RFI

RFI #: 1
Date: 4/25/2008
Job: 07-20-2046 Hoosic Valley School
Phone:

Subject: HV01-1 - Score Board Steel

Project: HOOSIC VALLEY CENTRAL SCHOOL DISTRICT
 HOOSIC VALLEY ELEMENTARY SCHOOL

Drawing No.: RFI -1- SK1

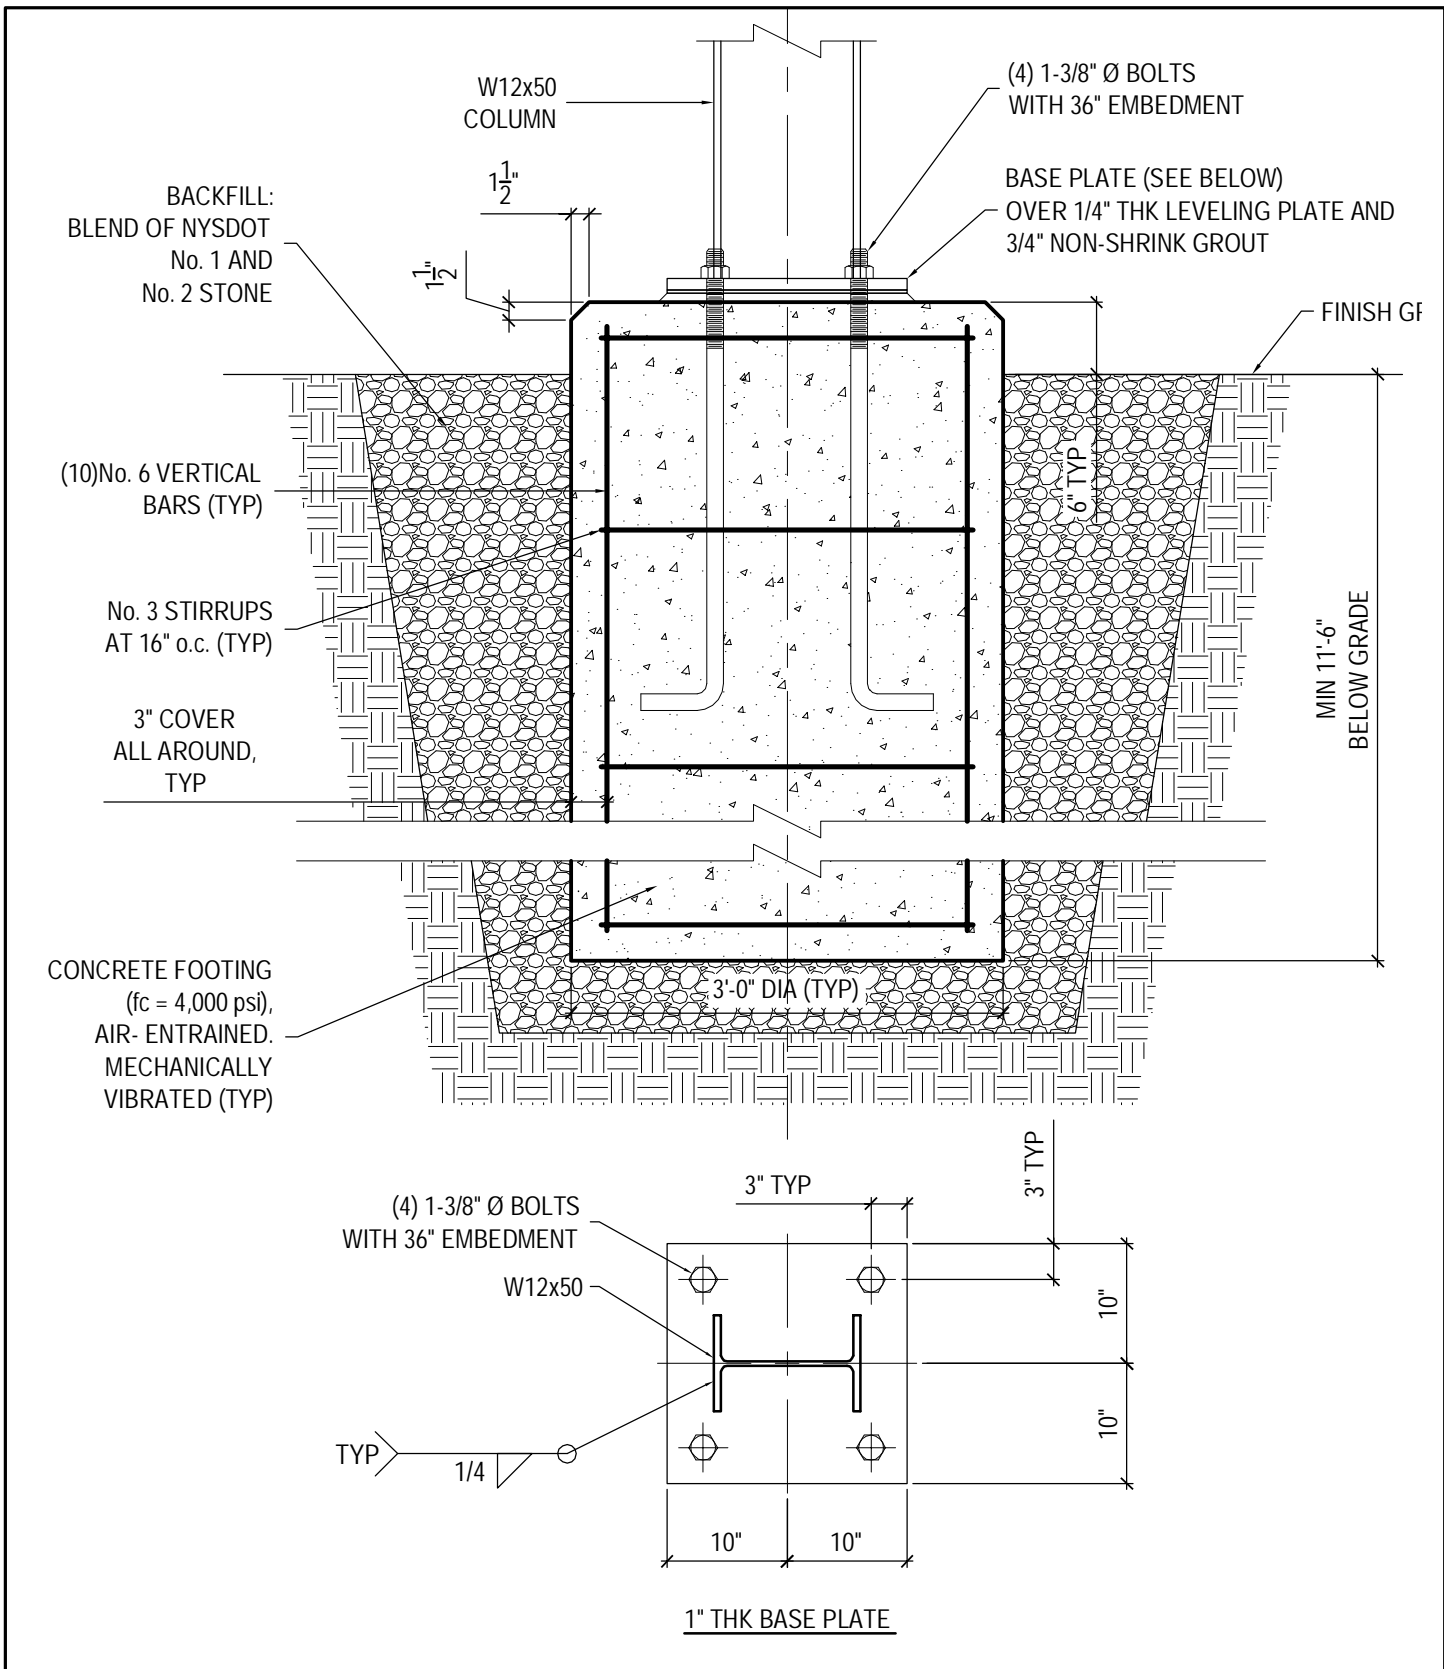
On Detail 1 of DWG CL-06, it shows W12 x 40 steel I beam powder coated and cast into concrete base.

- 1) A alternate method would be anchor bolts cast in base with a steel plate welded to base of I beam. This would allow for adjustments/plumbing of supports.
- 2) Also we cannot locate an oven for powdercoating a beam over 26'-0" in length.
- 3) There also would be a cost savings associated for shortening steel beams.
- 4) If you do not elect this please provide a vendor which can powder coat these beams.

See attached RFI-1 SKI-1 showing an alternate base plate with anchor bolt details. This will be an acceptable installation instead of embedding the column, and modifies Detail 4/S600.
